Docket Number:	15-AFC-01
Project Title:	Puente Power Project
TN #:	206245
Document Title:	Oxnard Fire and Police Response Capacity Letter
Description:	Oxnard Response to Law Enforcement Needs Letter TN# 205741, Dated August 14, 2015, Filer Lisa Worrall
Filer:	PATRICIA LARKIN
Organization:	Shute, Mihaly & Weinberger LLP
Submitter Role:	Intervenor Representative
Submission Date:	10/1/2015 9:53:17 AM
Docketed Date:	10/1/2015

**RE: Docket 15-AFC-01, Oxnard Response to Law Enforcement Needs Letter
TN# 205741, Dated August 14, 2015, Filer Lisa Worrall**

Figure 1.1 - Combined Hazard Zones for Planning Area 1: McGrath / Mandalay Beach

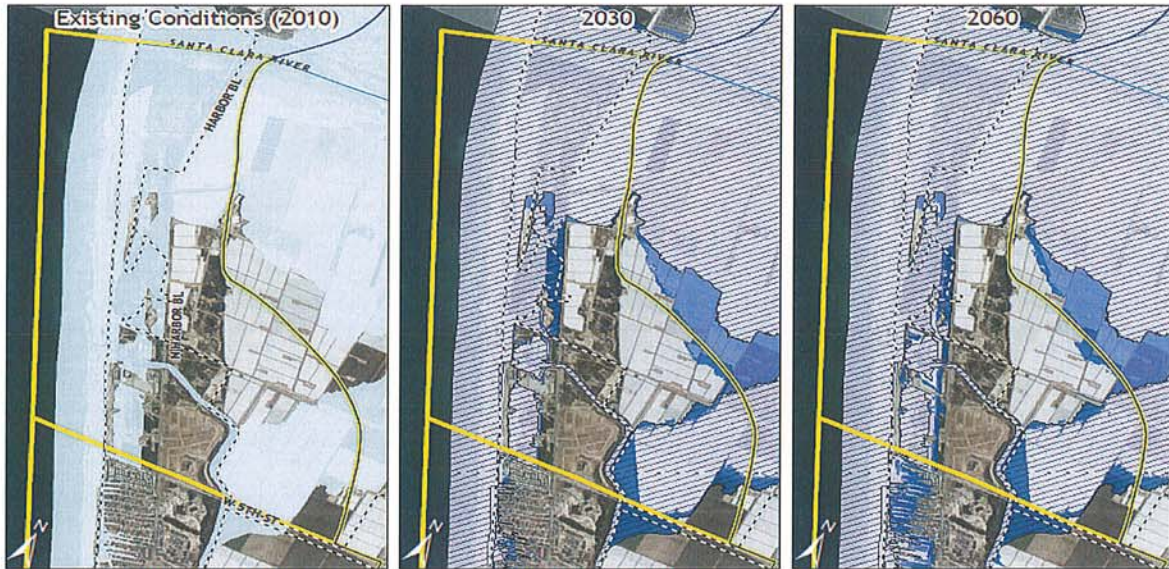
The City has completed a draft Sea Level Rise (SLR) Map Atlas (Atlas) for the LCP Update now in progress. The Atlas divides the Oxnard Coastal Zone into four planning areas. The MGS and P3 are located in Planning Area 1, *McGrath/Mandalay Beach*. On the following page is Figure 1.1, *Combined Hazard Zones for Planning Area 1: Existing, 2030, and 2060*, which shows considerable flooding potential from the Santa Clara River coming southward over the open fields. The interior areas around the MGS and P3 are flooded, as well as portion of Harbor Boulevard. Figure 1.5 depicts coastal storm flood hazards and, by 2060, flooding of Harbor Boulevard both north and south of the canal bridge under the high SLR modeling scenario. The 2060 scenario should be interpolated with the 2030 scenario to create a 2050 scenario, the proposed end of the P3 operational lifespan.

These maps establish, at a minimum, the risk of flooding at some depth in and around the MGS and P3 facilities by any of several coastal storm, heavy rain riverine flooding, and/or a dam failure events. The existing coastal and riverine flooding scenarios increase during the 30-year life span of the P3 facility. Soon-to-be-released FEMA CCAMP maps will provide depth information for existing coastal flooding scenarios. With this information as context for accessing the MGS and P3 facilities, the Oxnard Police and Oxnard Fire Departments emergency response information below is provided in two scenarios: 1) under normal present conditions, and 2) worst case flood scenarios.

"Probable Depth Map for Probable Maximum Flood, Hypothetical Failure of Santa Felicia Dam"

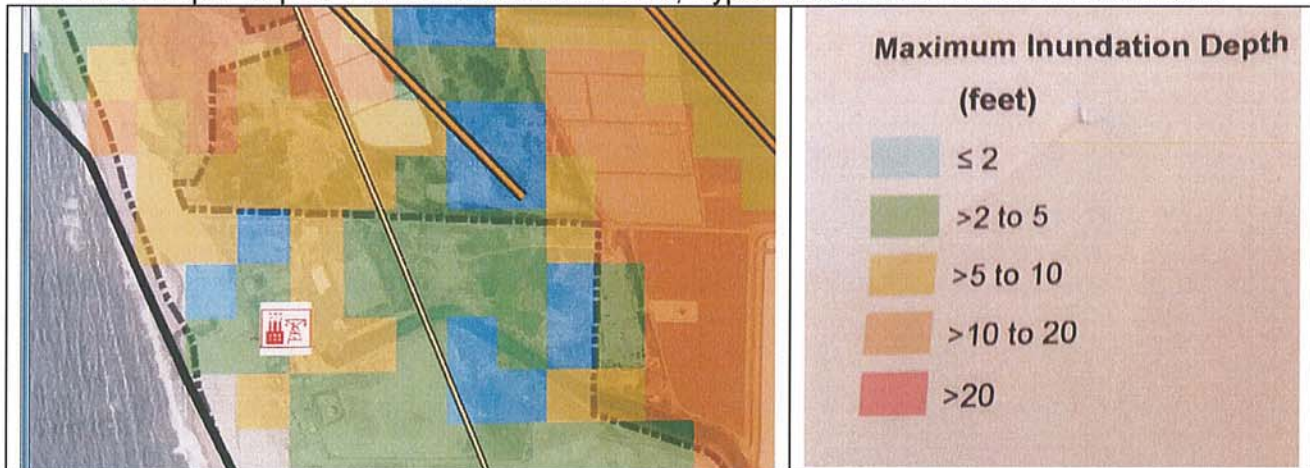
Below is a portion of the United Water Conservation District's *Probable Depth Map for Probable Maximum Flood, Hypothetical Failure of Santa Felicia Dam (Lake Piru)* completed in 2013. This map shows depths of 2-5 and 5-10 feet in and around the MGS and P3 locations should either the Lake Castaic or Lake Piru dams fail, creating a regional flood event similar to the 1928 failure of the St. Francis Dam.
